Access Compliance Report Public Rights-of-Way (Pedestrian Signals)

Main Street: **RANCHO_SANTIAGO_BVLD** Cross Street: **E_CHAPMAN_AVE** Location: **S**

ADA ID: **SGRK211223130511** Signal Type: **Two Push Buttons-Non APS** Overall Compliance: **No** Severity Scores: **BTN 1: 35** **BTN 2: 35** **No BTN: N/A**

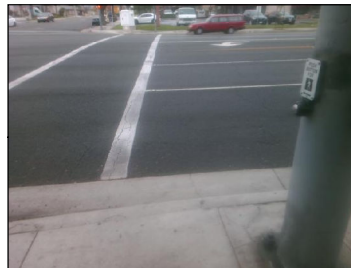
Compliance	Description	Data	Compliance	Description	Data
	Button Count	Button2	N/A	Distant to Additional Button (in)	N/A
	Additional Button Present?	No	N/A	Additional Button ID	N/A
	Located In An Island/Median?	No			
N/A	B 1 Sign Present?	Yes	N/A	B 2 Sign Present?	Yes
Yes	B 1 Sign Purpose?	Yes	Yes	B 2 Sign Purpose?	Yes
Yes	B 1 Sign Lettering & Contrast?	Yes	Yes	B 2 Sign Lettering & Contrast?	Yes
Yes	B 1 Parallel To XWalk?	Yes	Yes	B 2 Parallel To XWalk?	Yes
N/A	B 1 PAR to Button?	N/A	N/A	B 2 PAR to Button?	N/A
N/A	B 1 PAR to XWalk?	N/A	N/A	B 2 PAR to XWalk?	N/A
Yes	B 1 Clear Floor Space?	Yes	Yes	B 2 Clear Floor Space?	Yes
N/A	B 1 FWD Approach?	N/A	N/A	B 2 FWD Approach?	N/A
N/A	B 1 FWD Approach Constrained?	N/A	N/A	B 2 FWD Approach Constrained?	N/A
N/A	B 1 FWD Approach Reach (in)	N/A	N/A	B 2 FWD Approach Reach (in)	N/A
N/A	B 1 FWD Approach Width (in)	N/A	N/A	B 2 FWD Approach Width (in)	N/A
N/A	B 1 FWD Approach Obstruction?	N/A	N/A	B 2 FWD Approach Obstruction?	N/A

N/A	B 1 FWD Approach Obstruction Dist (in)	N/A	N/A	B 2 FWD Approach ObstructionDist (in)	N/A
N/A	B 1 PARA Approach?	N/A	N/A	B 2 PARA Approach?	N/A
N/A	B 1 PARA Approach Constrained?	No	N/A	B 2 PARA Approach Constrained?	No
Yes	B 1 PARA Approach Reach (in)	0	Yes	B 2 PARA Approach Reach (in)	0
N/A	B 1 PARA Approach Width (in)	N/A	N/A	B 2 PARA Approach Width (in)	N/A
N/A	B 1 PARA Approach Obstruction?	No	N/A	B 2 PARA Approach Obstruction?	No
N/A	B 1 PARA Approach Obstruction Dist (in)	N/A	N/A	B 2 PARA Approach Obstruction Dist (in)	N/A
Yes	B 1 Clear Floor Space Slope (%)	0.4	Yes	B 2 Clear Floor Space Slope (%)	3.9
No	B 1 Clear Floor Space XSlope (%)	5.3	No	B 2 Clear Floor Space XSlope (%)	4.1
N/A	B 1 PAR Slope (%)	0.6	N/A	B 2 PAR Slope (%)	5.2
Yes	B 1 Height (in)	46	Yes	B 2 Height (in)	46
Yes	B 1 Pressure (#)	5	Yes	B 2 Pressure (#)	5
Yes	B 1 Closed Fist Operation?	Yes	Yes	B 2 Closed Fist Operation?	Yes
Yes	B 1 Diameter (in)	2	Yes	B 2 Diameter (in)	2

N/A	B 1 Crossing Direction	N	N/A	B 2 Crossing Direction	W
No	B 1 DistanceTo XWalk (in)	64	Yes	B 2 DistanceTo XWalk (in)	0
Yes	B 1 DistanceTo Curb (in)	36	Yes	B 2 DistanceTo Curb (in)	50

Possible Solutions: Replace Signal Push Button With APS Button. Remove & Relocate Sign. Remove and Replace Clear Space.
